8. Well Name and No. RUTHLESS 11 FED COM/701H

9. API Well No. 3002547723

EOG respectfully requests an amendment to our approved APD for this well to reflect the following changes:

#### Revised Permit Information 03/04/2022:

## WELL LOCATION AND ACREAGE DEDICATION PLAT

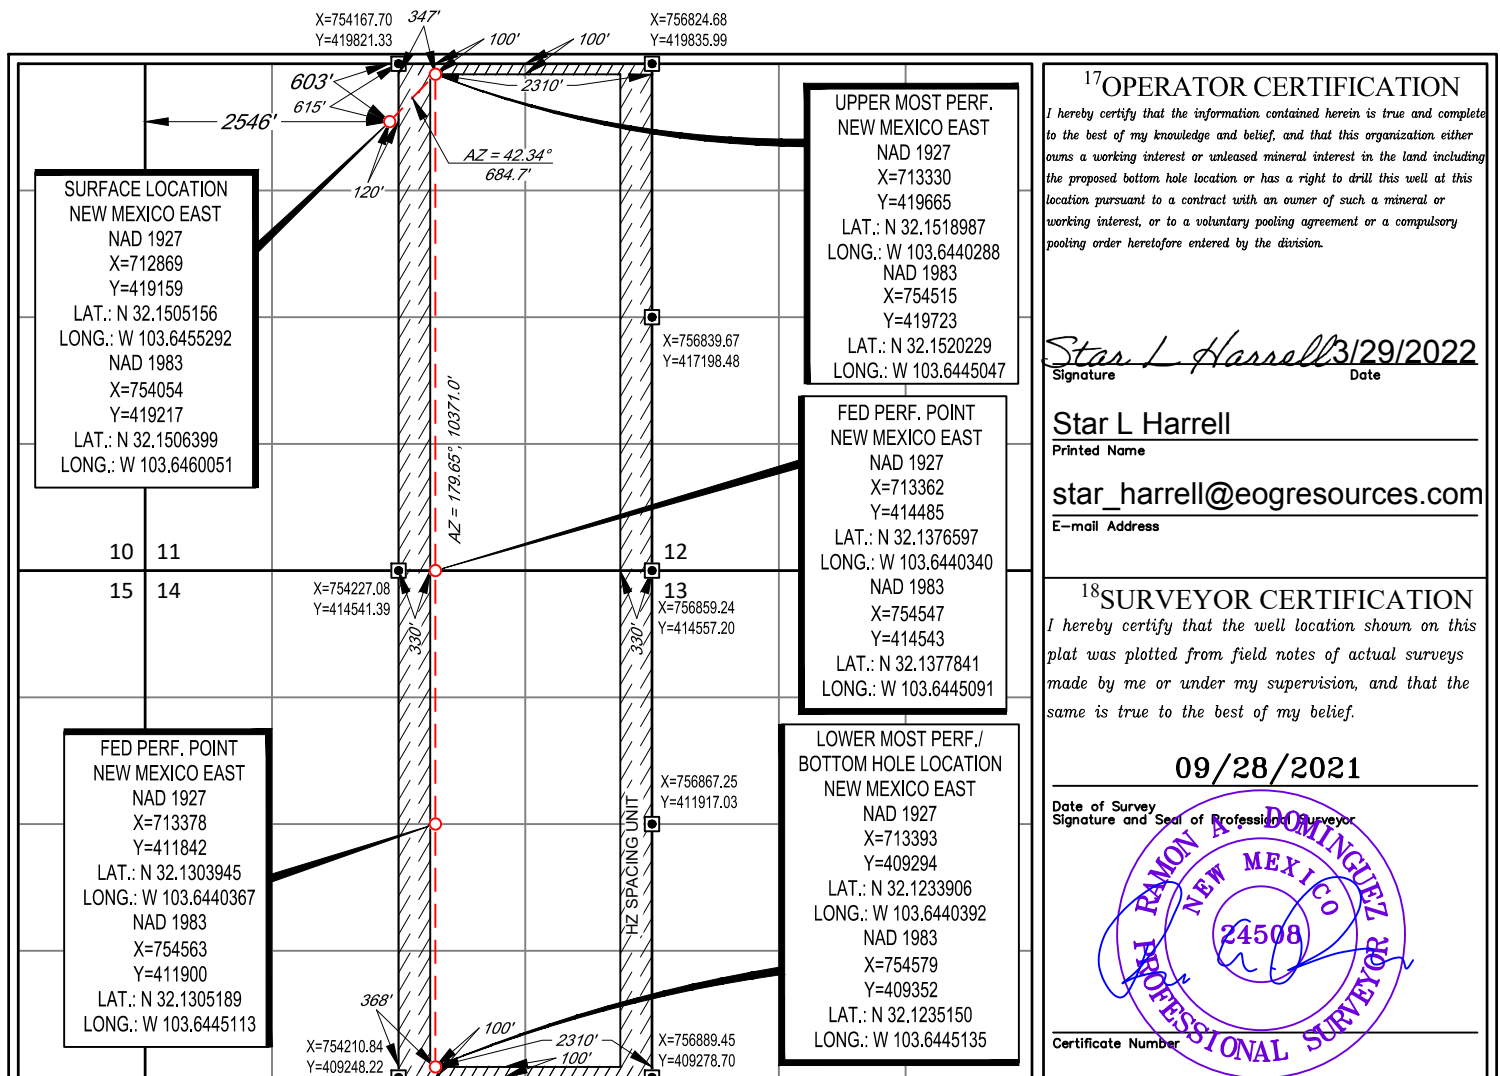
Change name from 701H to Ruthless 11 Fed Com 732H.

Change SHL from T-25-S, R-32-E, Sec 11, 600' FNL, 627' FWL, Lea Co., NM, to T-25-S, R-32-E, Sec 11, 603' FNL, 2546' FWL, Lea Co., N.M.

Change BHL from T-25-S, R-32-E, Sec 14, 100' FSL, 330' FWL, Lea Co., NM, to T-25-S, R-32-E, Sec 14, 100' FSL, 2310' FEL, Lea Co., N.M.

UL or lot no.	Section	Township	Range	Lot Idn	Feet from the	North/South line	Feet from the	East/West line	County
<b>C</b>	<b>11</b>	<b>25-S</b>	<b>32-E</b>	<b>-</b>	<b>603'</b>	<b>NORTH</b>	<b>2546'</b>	<b>WEST</b>	<b>LEA</b>

UL or lot no.	Section	Township	Range	Lot Idn	Feet from the	North/South line	Feet from the	East/West line	County
<b>0</b>	<b>14</b>	<b>25-S</b>	<b>32-E</b>	<b>-</b>	<b>100'</b>	<b>SOUTH</b>	<b>2310'</b>	<b>EAST</b>	<b>LEA</b>
